## Template for comments and secretariat observations: USA

Date: 2016_02_25	Document: ISO FDIS_7637- 3	Project:
------------------	----------------------------	----------

Figure 2 – Test set-up for CCC method – DUT Test

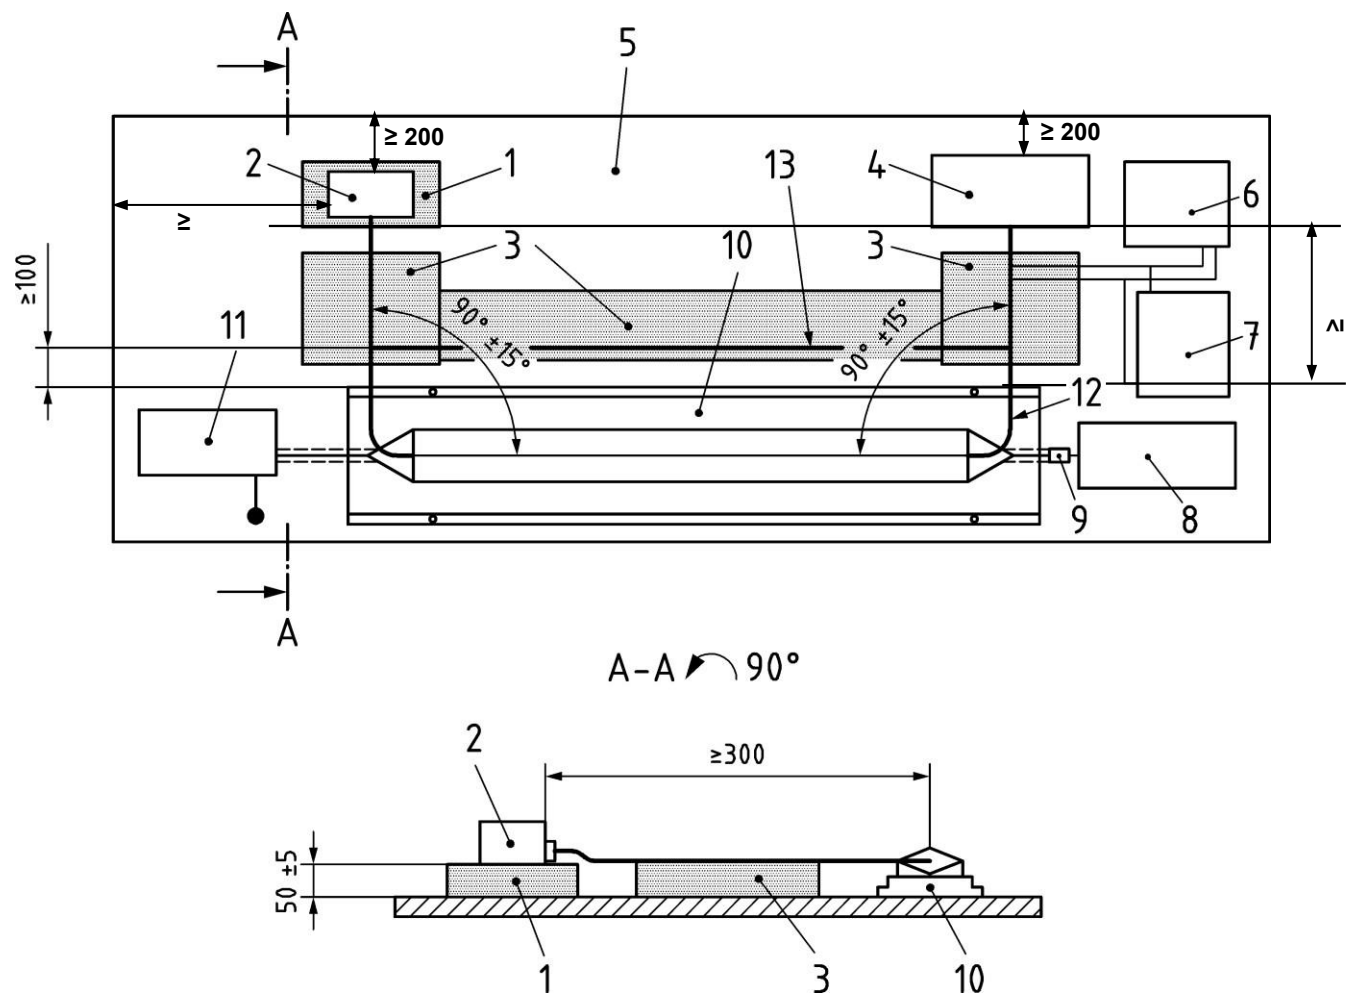
US 11	4.5.4	Figure 2	ed	Figure dimensions are incomplete (e.g. distances between DUT and CCC not shown)	Update Figure for clarity	
US 12	4.5.4	Paragraph 8 & 9		Information regarding DUT setup is redundant with information provided in 4.4	Delete paragraphs 8 and 9 per US4	
US 13	4.6.3	1 <sup>st</sup> bullet point under paragraph 1	ed	Text states that “The transient pulse level shall be measure using a high impedance passive probe.” No parameters are provided regarding the characteristics of this probe. Text should reference ISO 7637-2.	Proposed text change: “The transient pulse level shall be measure using a high impedance passive probe whose characteristics conform with that delineated in ISO 7637-2”	
US 14	4.6.3	Figure 3a	ed	Figure key lists passive probe. Should also include reference to ISO 7637-2	Proposed text change: “6. high impedance passive probe (see ISO 7637-2)”	
US 15	4.6.4	paragraph 4 & 5	ed	Information regarding DUT setup is redundant with information provided in 4.4	Delete paragraphs 4 and 5 per US4

Figure 7 – Test set-up for ICC method – DUT test

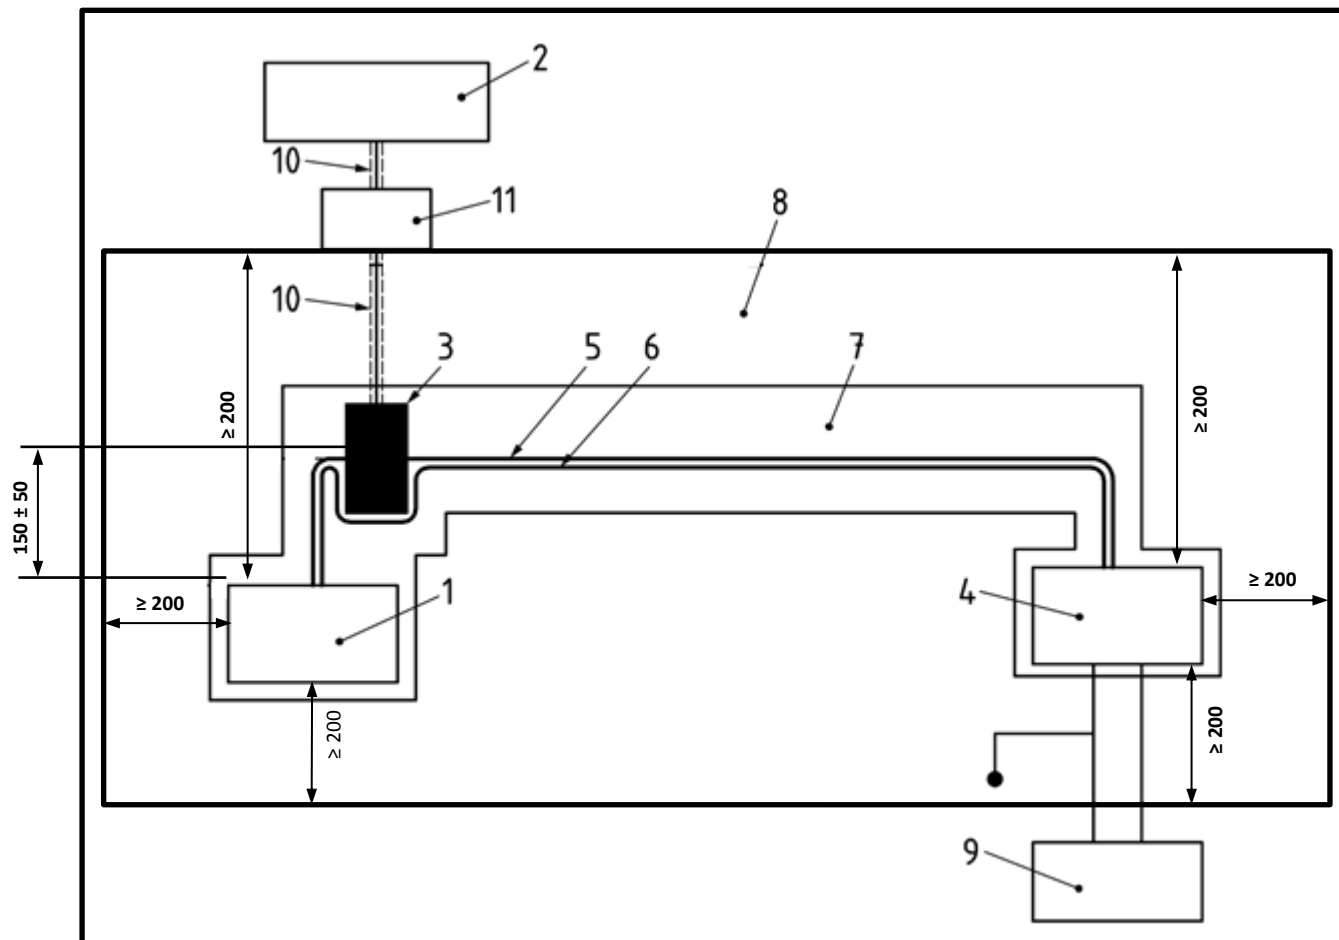
US 22	4.7.3	Last paragraph before Table 3	ed	Last sentence in paragraph states: "Information on the process used for estimating the inductive coupling factor is described in Annex C." What is the purpose of Annex C. Does anyone use it?	Delete Annex C unless there is a technical reason to keep it.	
US 23	4.7.4	1 <sup>st</sup> paragraph	te	Text states that DUT supply lines (ground and supply) are not to be included in CCC. However ground or supply delivered from DUT to auxiliary equipment (sensors, actuators) is okay to do. This is the same comments as delineated in section 4.5.4 (CCC method). As stated in US 8, the approach is fundamentally flawed because it assumes differences in source/load impedance.	Propose same approach as US 8	
US 24	4.7.4	2 <sup>nd</sup> paragraph	te	Text states that ICC test can be performed either as shown in Figure 7 or with a straight harness as implemented in ISO 11452-4. Within ISO 11452-4, the separation distance between DUT and edge of ground plan is to > 500 mm which conflicts with requirements in 4.3.	Delete entire paragraph. Test will be performed in accordance with that illustrated in Figure 7.
